MEMORANDUM

Date: June 29, 2012
To: 65-22723
From: Michele Edl
Re: Dam Safety inspection

IDAHO DEPARTMENT OF WATER RESOURCES
--- DAM SAFETY RECORD OF INSPECTION ---

photo date 8/10/2010 Courtesy J. Falk

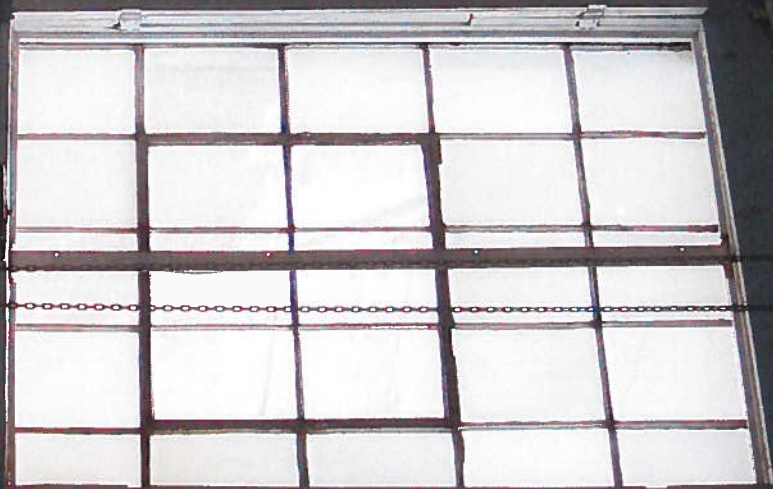
The photos confirm that the powerplant had been upgraded sometime before the August 2010 inspection.
